From: Thomas Strom <strom-thomas@levycounty.org>
Sent: Wednesday, October 7, 2026 2:28 PM
To: Patrick Mulhearn <pmulhearn@kcaeng.com>
Cc: Catrina Sistrunk <sistrunk-catrina@levycounty.org>
Subject: Dock Street

As discussed last week, the Levy County Tourism Committee has expressed interest in the potential construction of a decorative archway sign over Dock Street in Cedar Key. We would appreciate KSA's assistance in evaluating the feasibility of this concept and providing any conceptual recommendations. The two locations currently under consideration are the intersection of Dock Street and 1st Street and the east end of Dock Street, as shown below. I have also attached examples of the type of archway sign being contemplated. The proposed sign text would be "HISTORIC DOCK STREET."

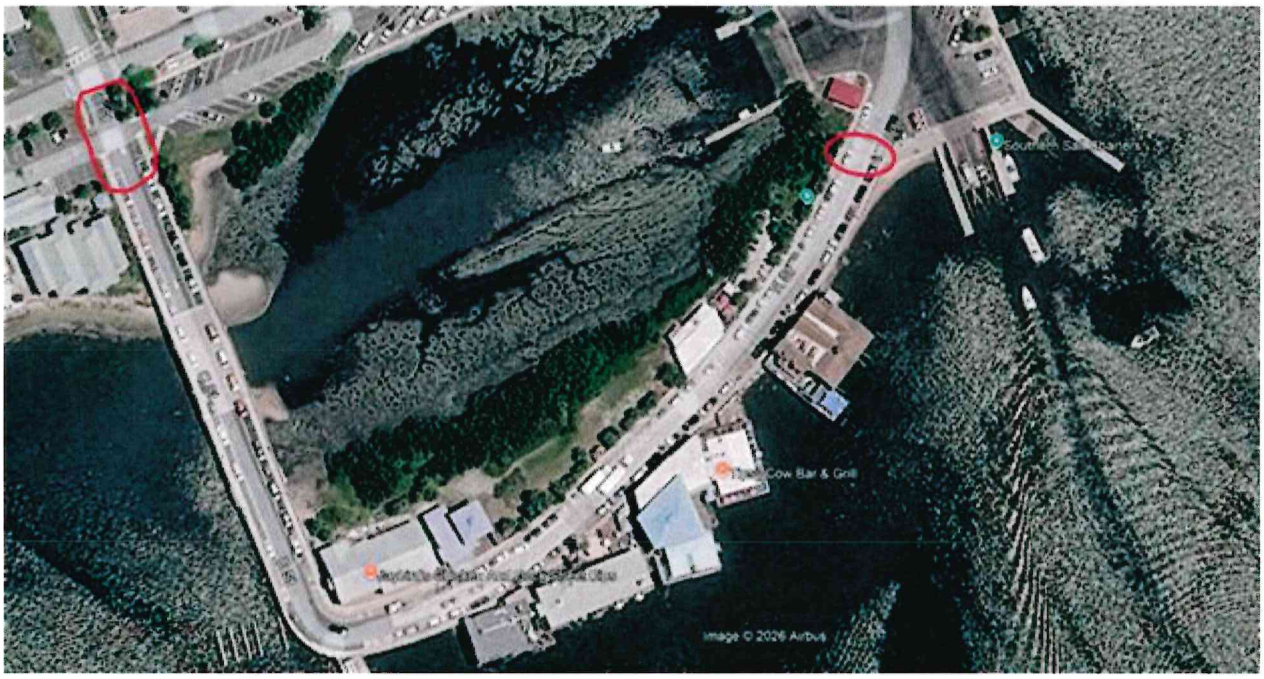
To assist with this discussion, we would appreciate your thoughts on the following:

1. Is a structure of this type feasible at either of the proposed locations based on the available right-of-way and site constraints? If not, would easements or alternative structural configurations potentially make the project feasible?
2. What vertical clearance would be recommended given the truck traffic, utility vehicles, and trailered boats that regularly use Dock Street?
3. What would be the approximate order-of-magnitude cost range for a sign of this nature, including foundations and installation?
4. Are there any significant concerns or constraints that the Committee should consider at this early stage?
5. If an overhead archway is not practical, are there alternative gateway-style concepts you would recommend?

At this stage, the County is simply trying to determine whether the concept is feasible and obtain a rough order-of-magnitude cost estimate to help inform future discussions with the Tourism Committee. One of my initial concerns is the amount of available right-of-way and space at the proposed locations.

The sign concept seems feasible. The required right-of-way would be minimal as the foundations will most likely be 3' to 4' diameter drilled shafts. It appears there is room at both locations. Though, we won't know for sure until survey is performed and utility locates are done.

The minimum vertical clearance can match standard FDOT clearance for bridges at 17.5'.

A main concern would be durability in the extremely aggressive environment, but using stainless steel or galvanized steel with regular maintenance coating should ensure its lifespan.

I would guess approximately $200,000 for a relatively straightforward archway. If lighting and detailed custom features are wanted it can approach $450,000.
